PROJECT: Meadows Multifamily

CITY OF LAS VEGAS		DATE:
INTER-OFFICE MEMORANDUM		December 16, 2020
TO: Land Development Services Department of Building & Safety		FROM: Albert Sung, P.E. Flood Control Project Engineer Department of Public Works
SUBJECT:	Drainage Study for:	COPIES TO:
	Meadows Multifamily	Wood Rodgers, Inc.
Cross Streets:	NEQ of Meadows Lane & Decatur Blvd.	Meadows Owner, LLC
File Number:	F:\Depot\DSMemos\DS5291B.doc	Bart Anderson, P.E., DevCo
Parcel Number:	139-31-111-010	
Zoning Action:	SDR-76721 & VAR-76720	
FEMA Flood Zone	YES	NO X
Proposed Storm Drain	YES	NO X

Addendum #1 to the
Technical Drainage Study
for
Meadows Multifamily
Meadows Ln @ Meadows Mall St Project

RE: Addendum #1 to the Technical Drainage Study for Meadows Multifamily (DS 5291)

FIGURE 5
DEVELOPED CONDITION DRAINAGE
MEADOWS MULTIFAMILY
LAS VEGAS, NV
JUNE 2020

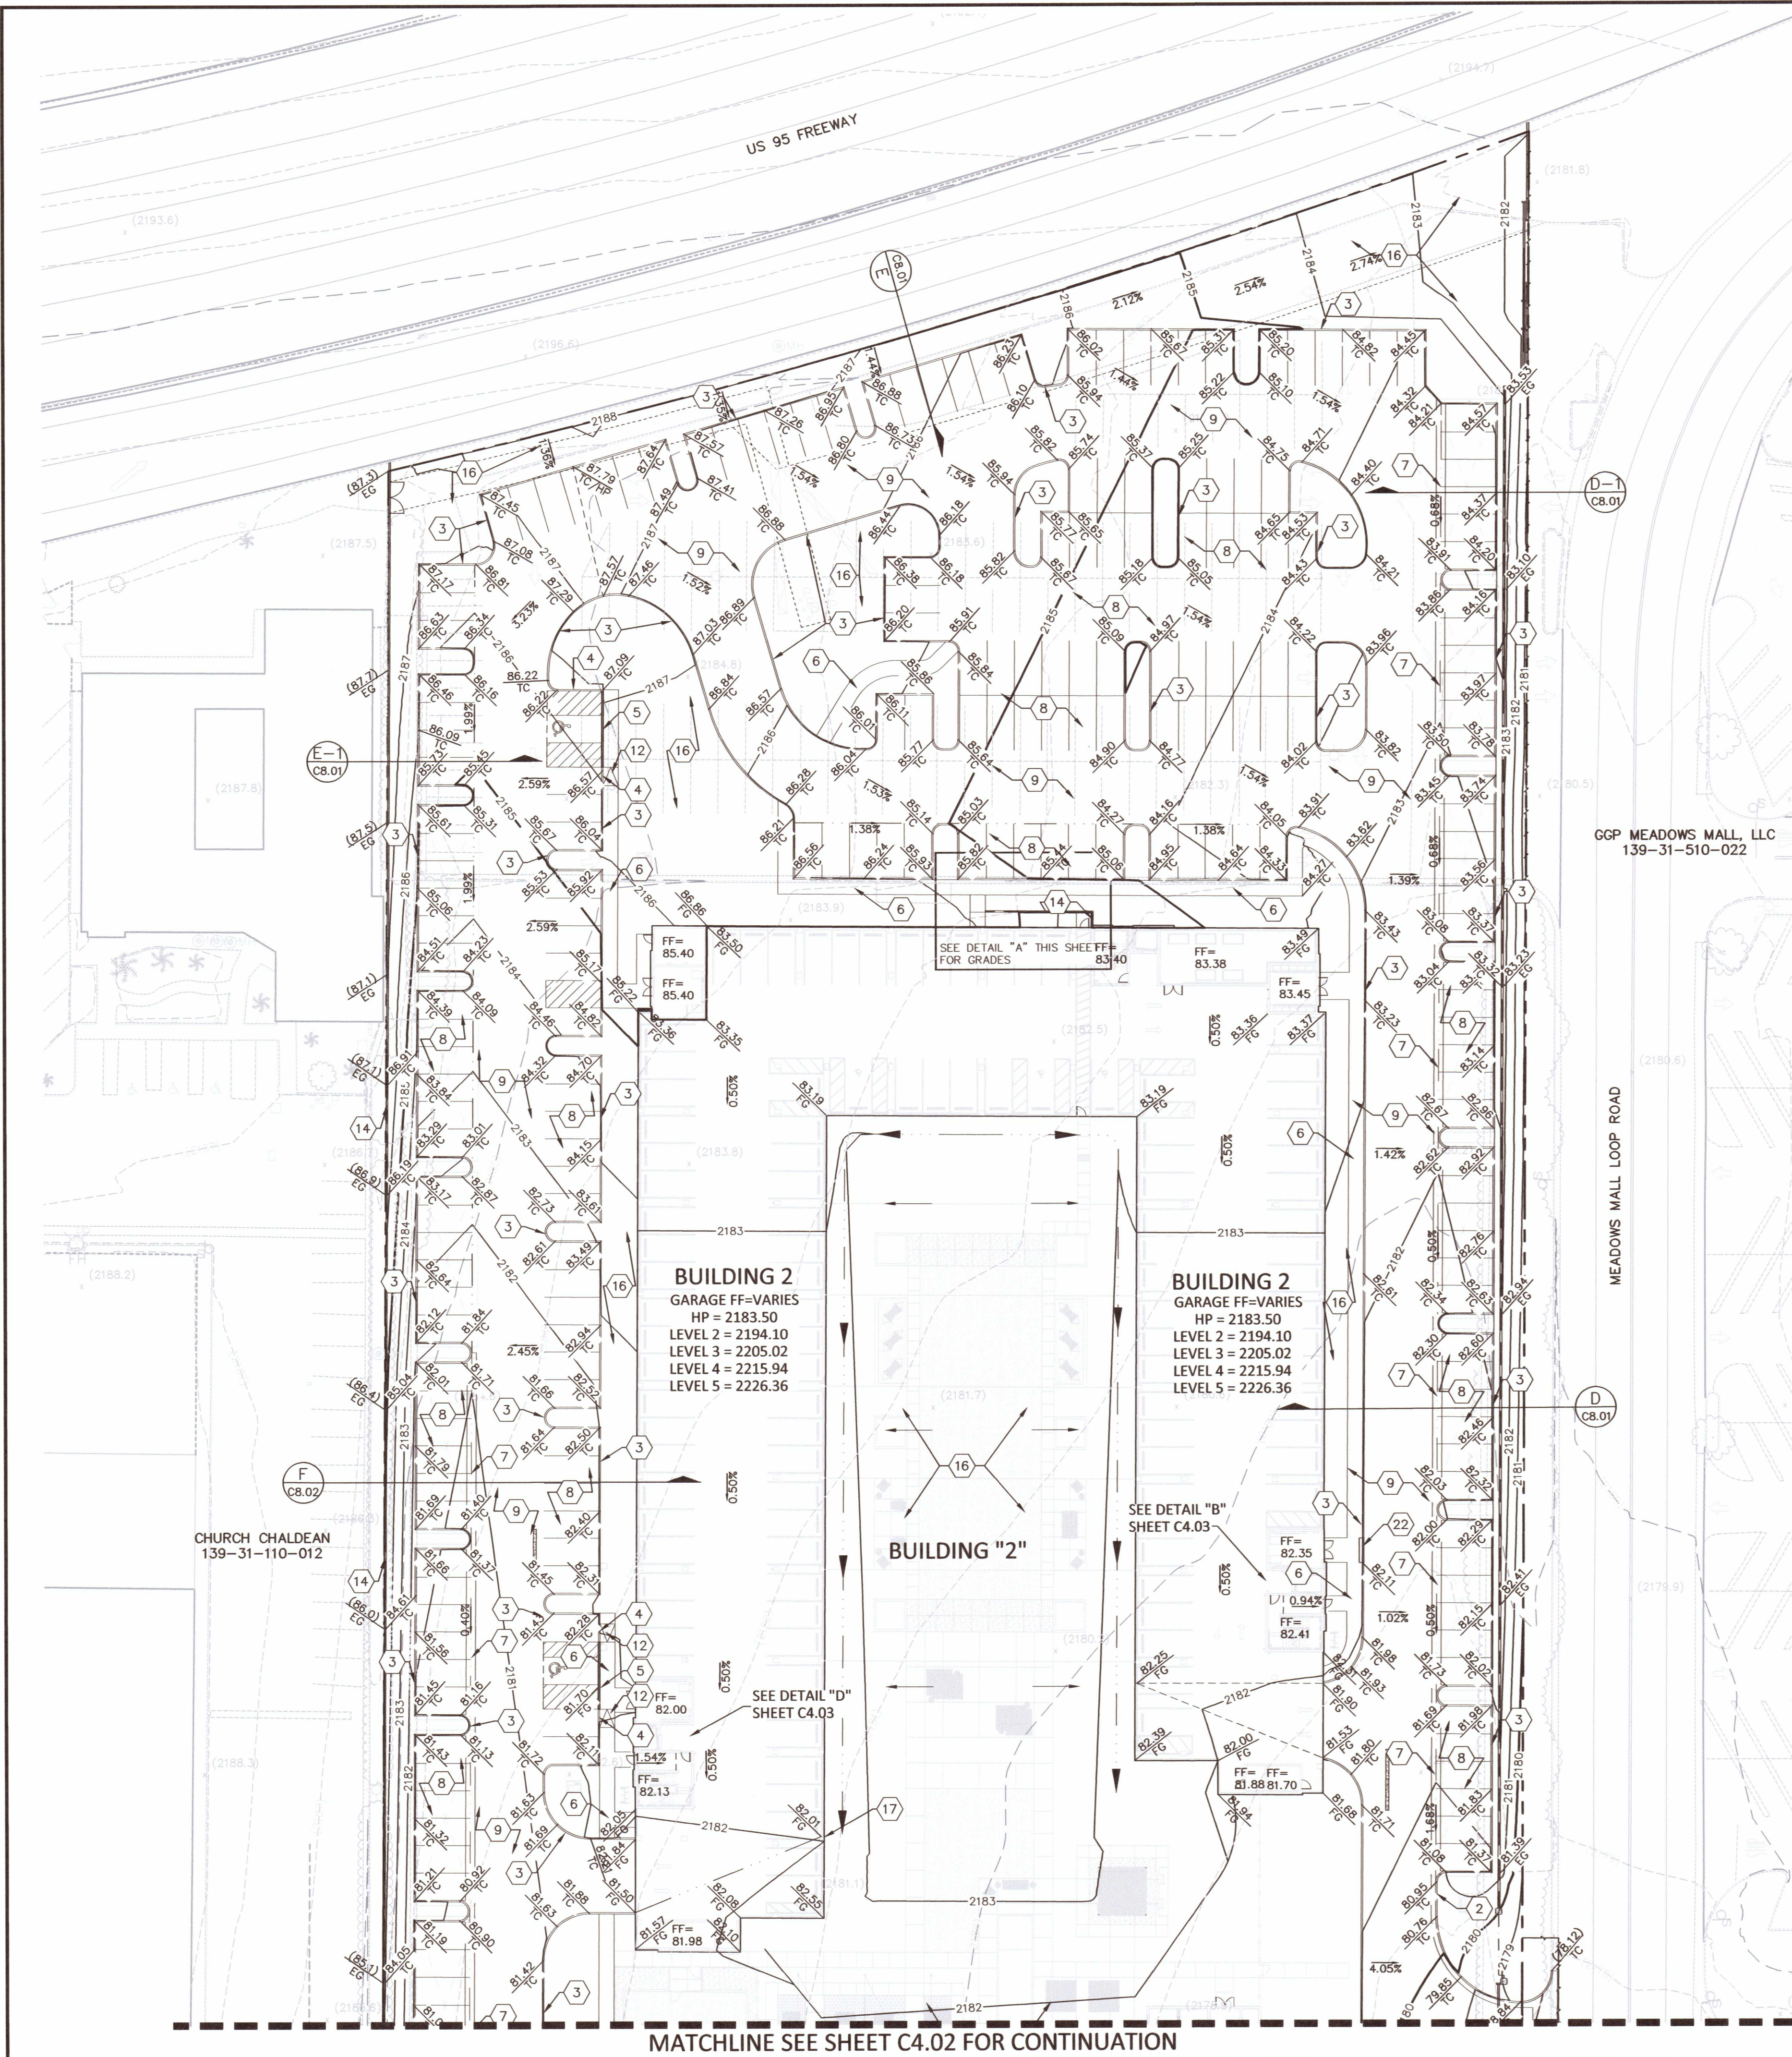
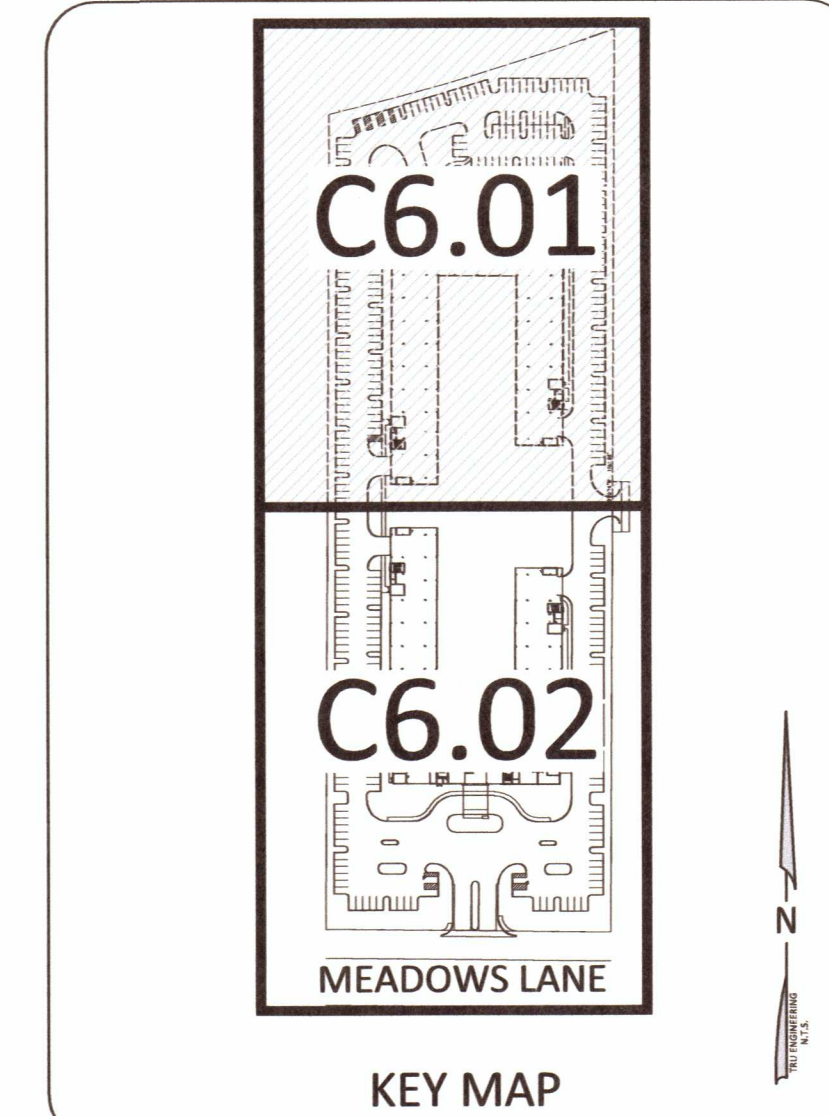
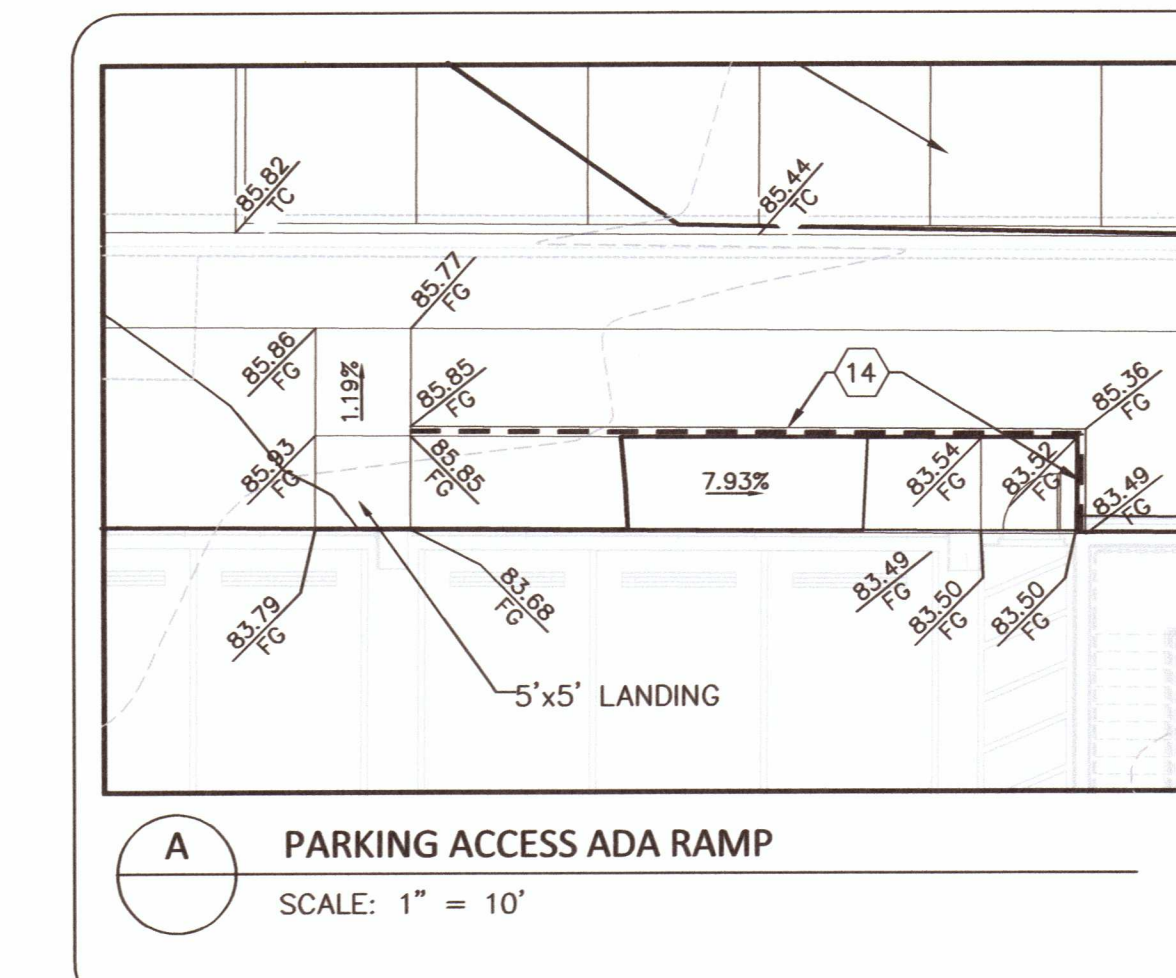
Comment 5 Figure 5 (Developed Condition Drainage Map): Basin OFD1 cannot be located on the map. Clearly identify the location of OFD1 in the next submittal.

Comment 6 In Chapter 3.2 (Ultimate Developed Drainage Condition), Offsite: quote: "Runoff from the future offsite basin OFD1 combines with flow from the developed onsite basin OND1 and OND2 at Combination Point CPD1 in Meadow Lane at the southeast corner of the Project." - end quote.

However, CPD1 cannot be identified anywhere on the drainage map, instead CPD3 and CPD4 were shown. Also logically, is there a CPD2 and where is it? Address and resolve in the next submittal.

Response 5 *Basin OFD1 has been labeled accordingly to the proper area on Figure 5 and included in Appendix E.*

Response 6 *Combination Point 1 (CPD1) is at the same location at CPD3 and CPD4. We elected not to route the combined flows (CPD1) or combined flows of OND1 and OND2 and so the resultant, flow is a bit more conservative. During the course of preparing the drainage study, we initially had a CPD2 and as we adjusted the drainage basins to conform to the site design, CPD2 was no longer needed and dropped. See enclosed Figure 5 – Developed Conditions Drainage map in Appendix E*

E MEADOWS LANE
C4.02 1" = 20'

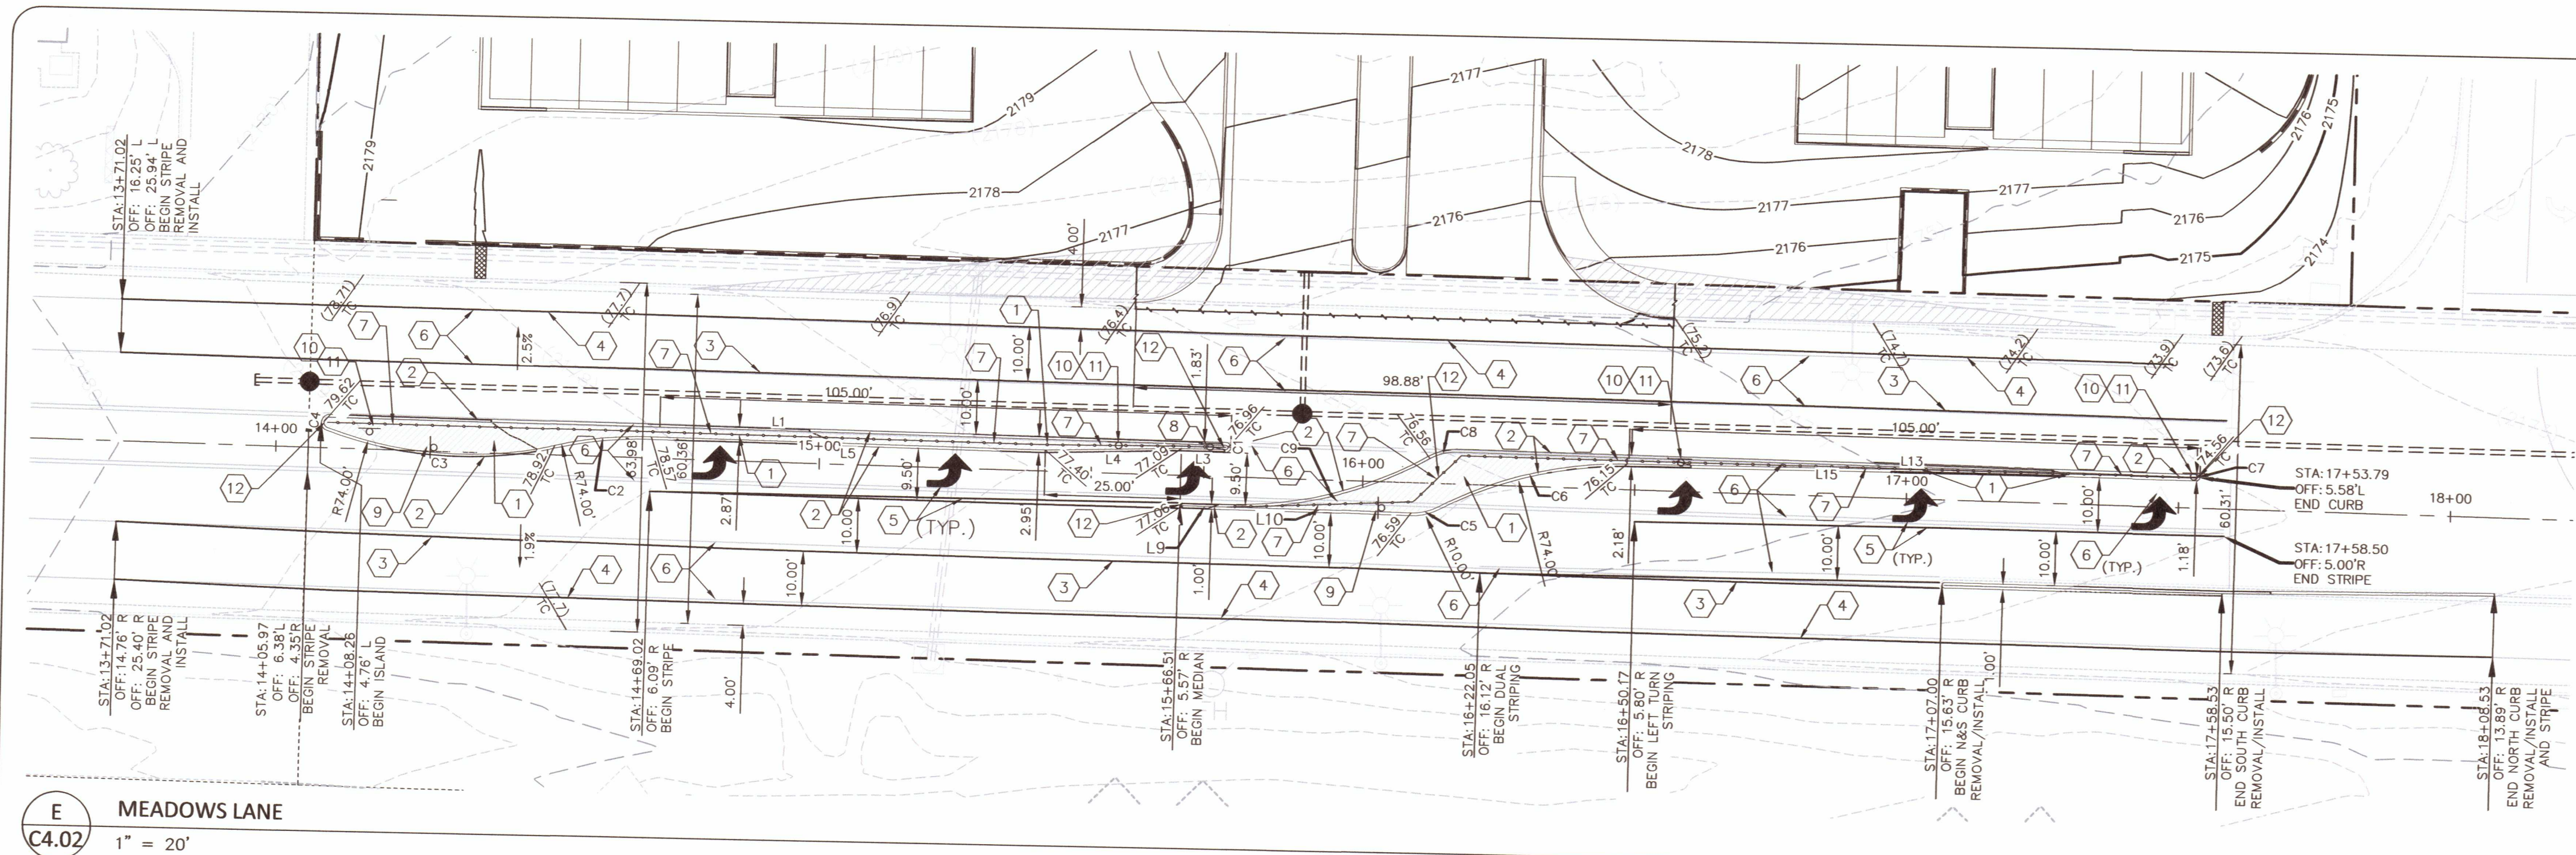
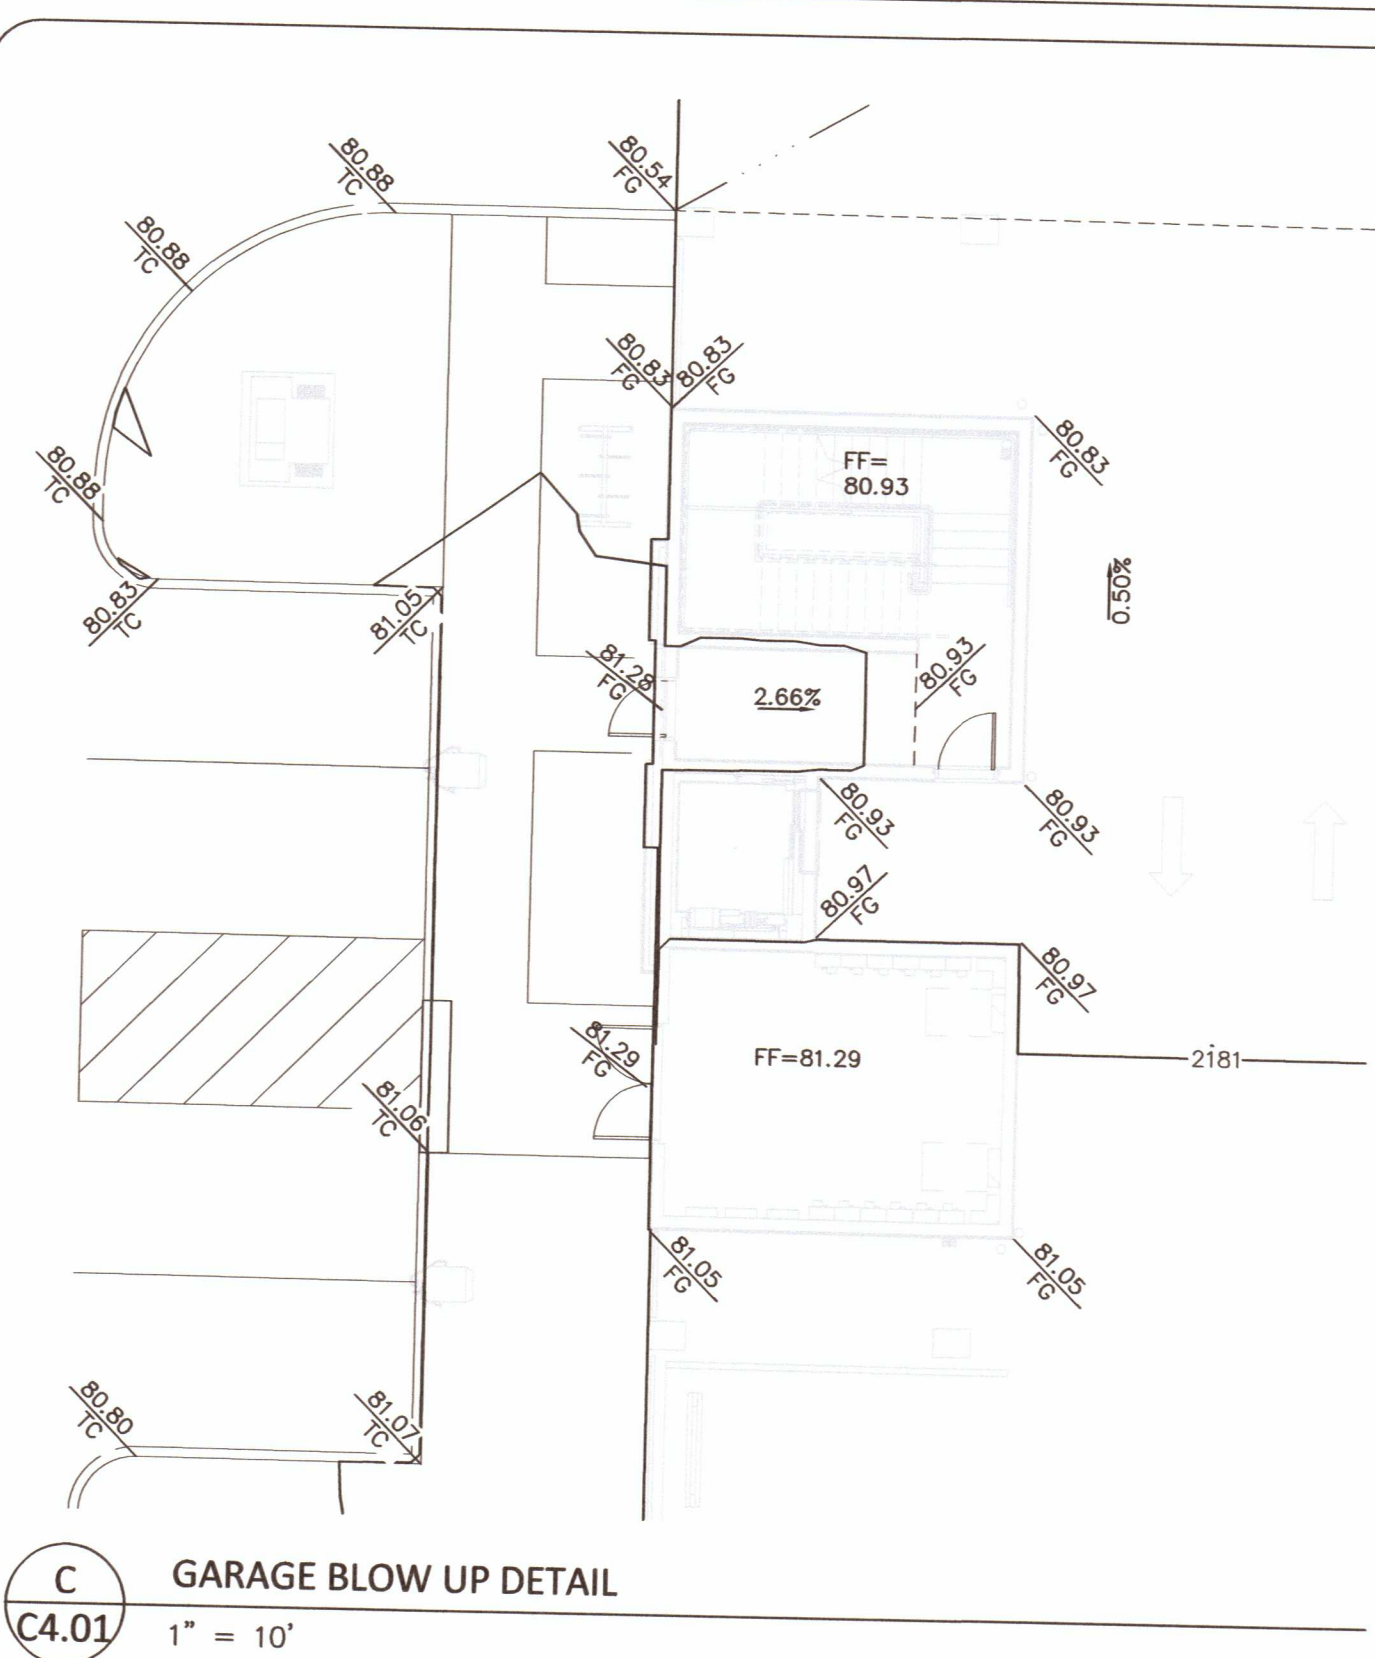
1. Provide 4# of sidewalk underdrains at each location of the proposed 12'-wide riprap in *Meadows Lane*.
